NIAGARA MOHAWK POWER CORPORATION

LICENSE NO. DPR-63

Proposed Changes to Technical Specifications (Appendix A)

Supporting Information and No Significant Hazards Consideration Analysis

FIGURE 1

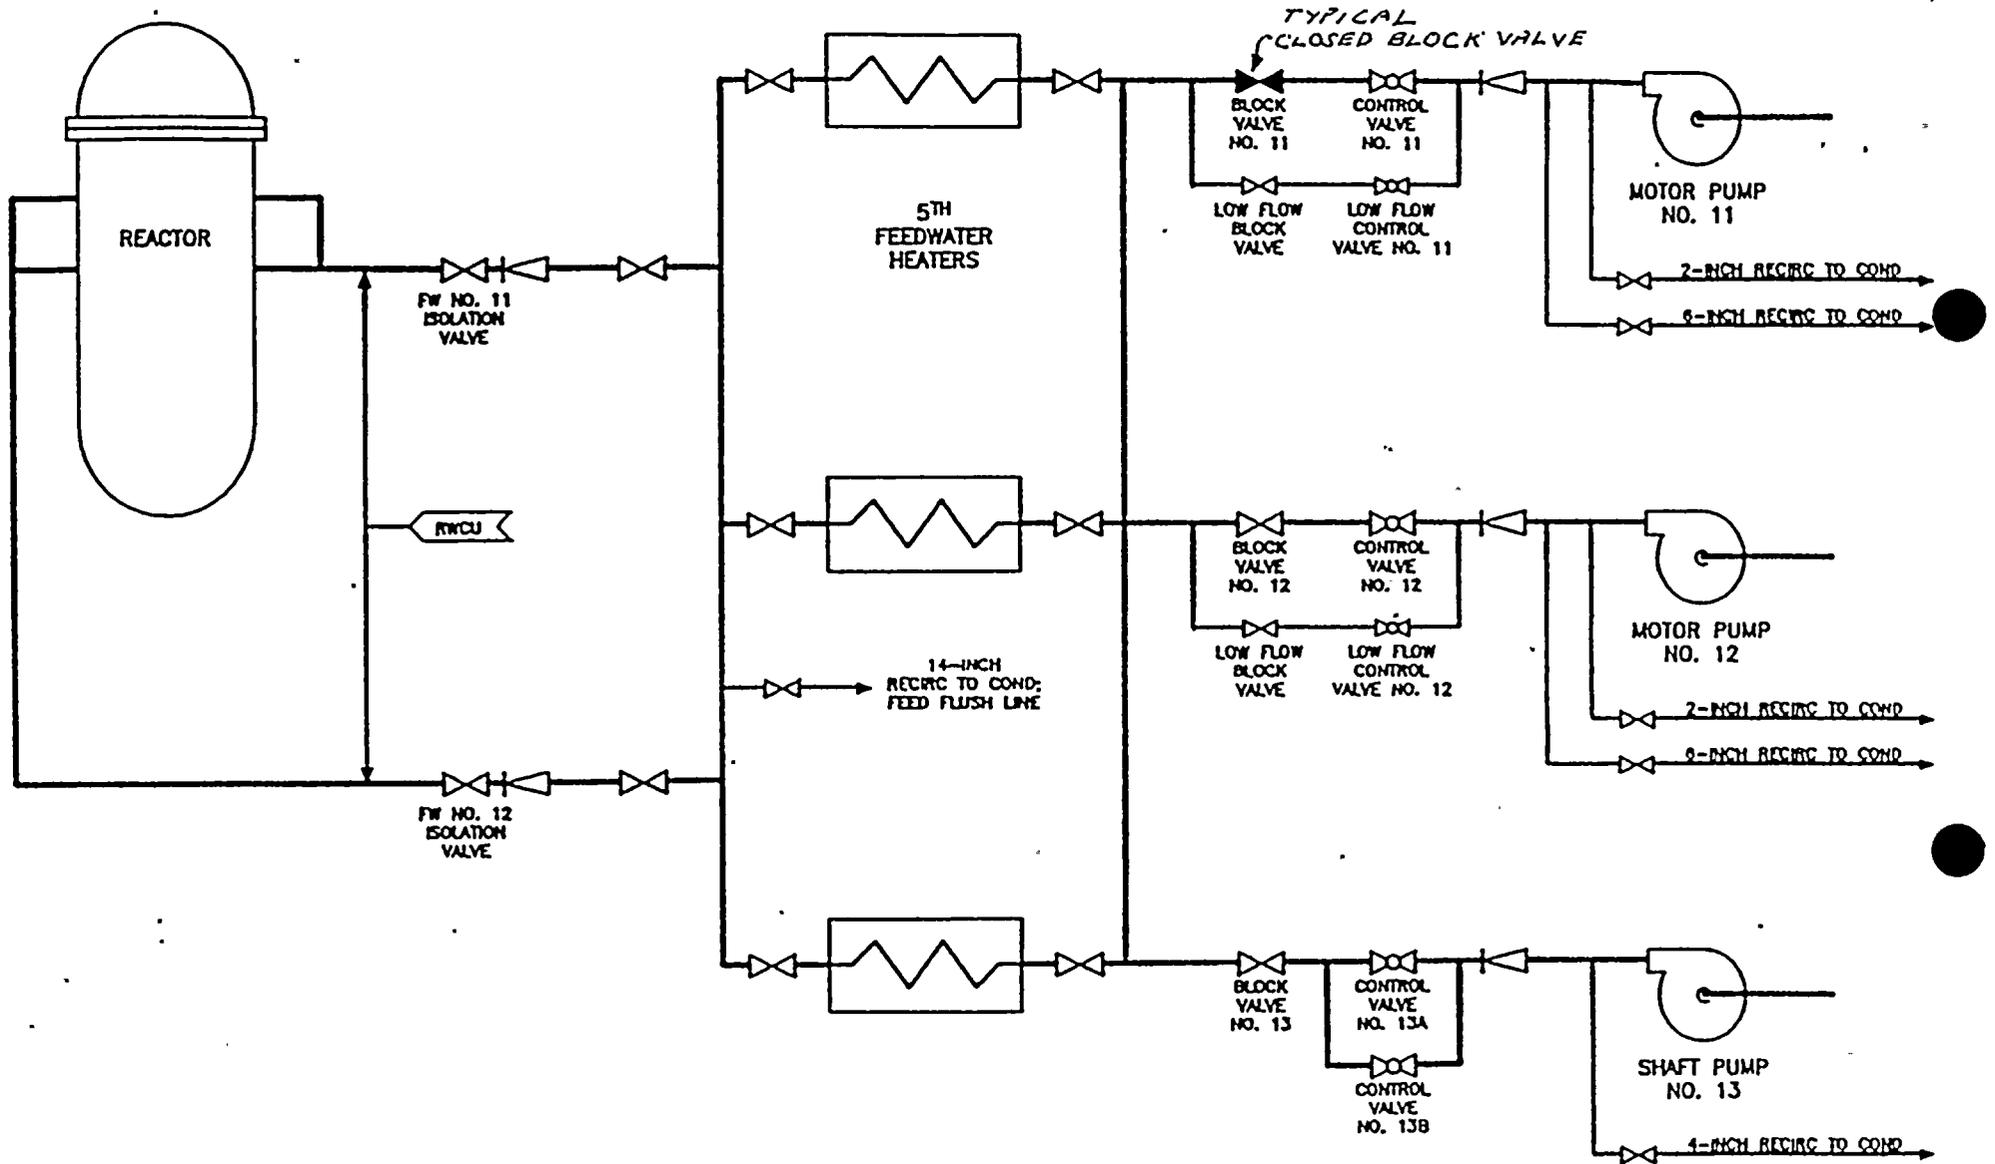
The proposed change will allow plant startup with the operating motor driven feedwater pump blocking valve in the closed position. This blocking valve is motor operated. The blocking valve on the other train would be open. In this evaluation, the term main flow control valve refers to Flow Control Valves 11 or 12 controlling flow of their respective electric motor driven feedwater pumps. The minimum flow control valve is a bypass valve around the main flow control valve and is intended to control feedwater flow during periods of low feedwater demand. Figure 1 shows a piping schematic.

It is estimated that the low flow control valve will pass approximately 1250 gpm of feedwater at reactor operating pressure. At lower reactor pressure, the amount would be larger (2000 gpm below 350 psi). The blocking valve will be opened prior to exceeding 25% rated thermal power.

When the reactor is in the process of startup, the LOCA makeup requirements are reduced because of lower pressures, decay heat, and reactor power than those assumed in Appendix K, 10 CFR 50 requirements. With the feedwater blocking valve closed. This feedwater train would be capable of providing approximately 1250 gpm of feedwater to the reactor up to a reactor pressure of 1050 psig. The other feedwater train (Preferred HPCI train) with its blocking valve open would remain capable of supplying 3800 gpm of feedwater upon automatic HPCI initiation at all reactor pressures. Plant procedure (NI-OP-43, Startup and Shutdown) is being revised to require reactor startup with the non-preferred HPCI train (Feedwater Pump 11) in service. Closure of the low flow by-pass valve on the operating train would occur on HPCI initiation but the reactor operator could manually initiate opening of the closed blocking valve. This valve would be open in approximately 60 seconds after initiation.
